<b>Title-Sujet</b> Logan Creek Bridge Construction – Pacific Rim National Park		
<b>Solicitation No. - No. de l'invitation</b> 5P420-17-5450/A	<b>Date:</b> January 26, 2018	
<b>GETS Reference No. – No de reference de SEAG</b> PW-18-00810188	<b>Amendment No. - N° de la modif.</b> PR00005	
<b>Solicitation Closes:</b>		
<b>at – á</b> 02:00 PM	<b>on – le</b> February 1, 2018	<b>Time Zone - Fuseau horaire</b> MST - HNR
<b>F.O.B. - F.A.B.</b> <b>Plant-Usine:</b> <input type="checkbox"/> <b>Destination:</b> <input checked="" type="checkbox"/> <b>Other-Autre:</b> <input type="checkbox"/>		
<b>Address Inquiries to: - Adresser toute demande de renseignements à :</b> Rebecca Chen		
<b>Telephone No. - No de téléphone</b> (403) 292-8509	<b>Fax No. – No de FAX:</b> 1-866-246-6893	
<b>Destination of Goods, Services, and Construction:</b> <b>Destinations des biens, services et construction:</b> See Herein – Voir ici

### Amendment 03

This amendment is being raised to extend the solicitation closing date and to distribute the presentation, attendees, meeting minutes, questions and answers from the bidder's conference.

**Project:** Logan Creek Bridge Construction

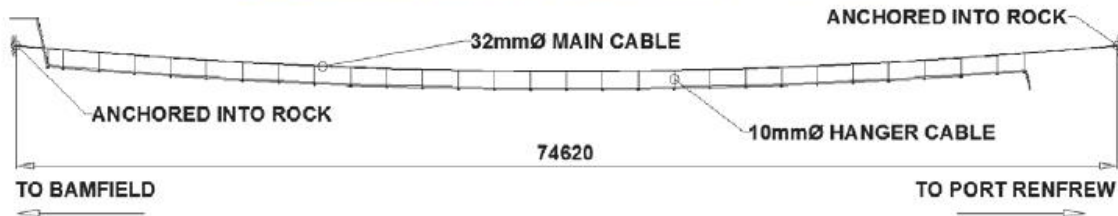
**Q14** As shown on Drawing S302 – Site Plan, the drawing noted "Provide new trail access to new bridge, actual location to be confirmed on site by DR". Please clarify if the new trail access is intended to be included in the scope of work.

**A14** Yes. Contractor will need to provide new trail access connecting the existing trail to new bridge on both ends.

ELEVATION

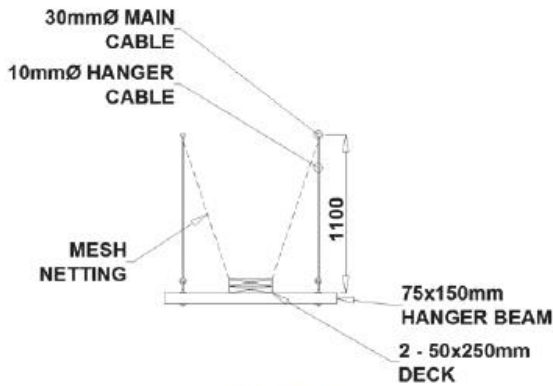
**Q16** Can as-built drawings of the existing bridge be provided? If drawings are not available can details of materials used be provided?

**A16** No existing as-built drawings are available. Please refer to the following information for details of existing bridge construction.

1. Timber suspension main span with 32.0 mm diameter main steel cable
2. Ladder approaches at each end of main span
3. Timber plank decking
4. Rope mesh railing
5. Clearance to water level 20 m
